**TRUCK, LIGHTWEIGHT, MC2, LAND ROVER 110 4X4 - ALL TYPES WITH WINCH  
TRUCK, LIGHT, MC2, LAND ROVER 10 6X6 - ALL TYPES WITH WINCH**

**REWORK OF THE WINCH DRUM GROOVES AND  
REPLACEMENT OF THE WINCH ROPE AND CHAIN**

**MODIFICATION INSTRUCTION**

**Figure 1 - Early and Later Style Winch Rope Configurations**

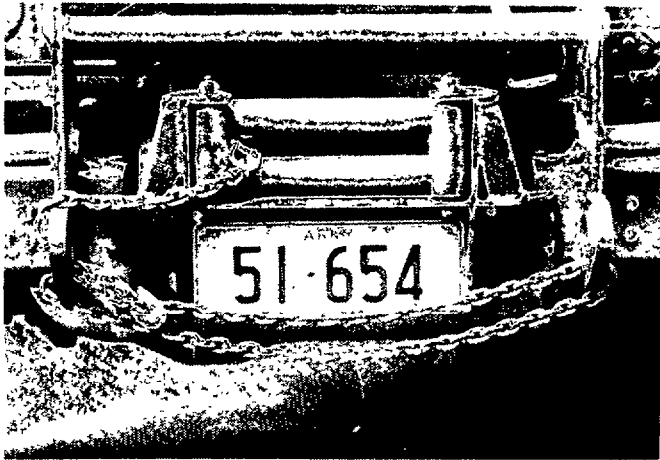
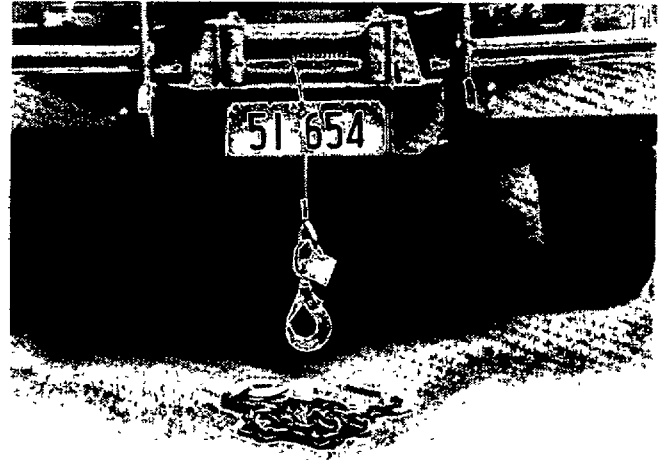
1. This instruction details the modification of the winch drum by the addition of a groove filler and the replacement of the existing winch ropes and 7.1 mm winch chain assemblies fitted to Land Rover 110 4x4 and 6x6. The new winch rope has a swivel latchlock hook fitted to the end and the rope has been increased from 1770 grade to 2070 grade. The rope diameters remain the same but the capacity of the rope now exceeds the bare drum capacity of the winch.

12. Figure 1 shows the early and later style winch rope configurations. Vehicles with the later style winch rope already fitted should only require the modification to the winch drum, however the rope should be inspected for serviceability. Land Rover 110 6x6 should be checked to ensure that the winch driveshaft has been modified as detailed in VEHICLE G 297-9. On receipt of stores carry out modification as follows:

- j. Refit the winch fairlead plate.
- k. Top up the winch oil with OEP 220 and install the filter plug.
- l. Fit a serviceable later type winch rope and swivel latchlock hook assembly (Item 1 or 2, Table 2 as applicable) to the winch drum.
- m. Lubricate the rope with ZX-8 grease and wind the rope onto the drum.
- n. Install the chain assembly (see Para 13 and Table 4 for applicable vehicles) on the vehicle.

**Figure 2 - Winch Drum Groove Filler Rod Installation**

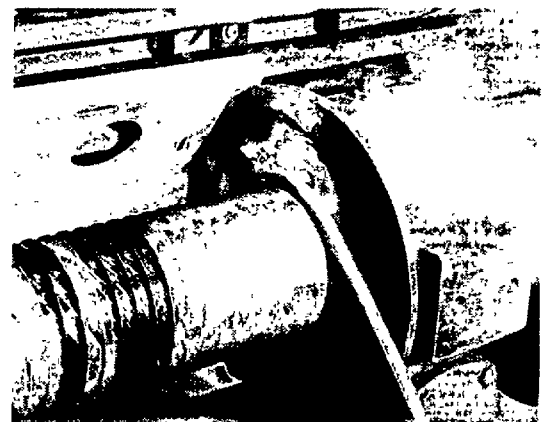
- a. Remove the winch rope from the winch drum.
- b. Remove the winch fairlead plate (place a container under the gear housing to catch oil).
- c. Grind the end of the groove filler rod (Item 1, Table 3) to allow an easy fit between the first drum groove and the winch drum end flange adjacent to the rope securing point (see Fig 2).

- d. Tack weld the filler rod in place.
- e. Rotate the winch drum anti-clockwise, bending the filler rod around the drum to follow and fit into the winch drum groove (see Fig 2). Tack weld the filler in place at 60 degree intervals.
- f. Continue bending the rod until the grub screw position is reached.
- g. Cut off the excess filler rod leaving a gap of approximately 5 mm between the end of the filler rod and the grub screw access hole (see Fig 2).
- h. Weld a small filler section (approximately 2 cm) between the grub screw and the winch rope access hole (see Fig 2).
- i. Paint damaged areas.
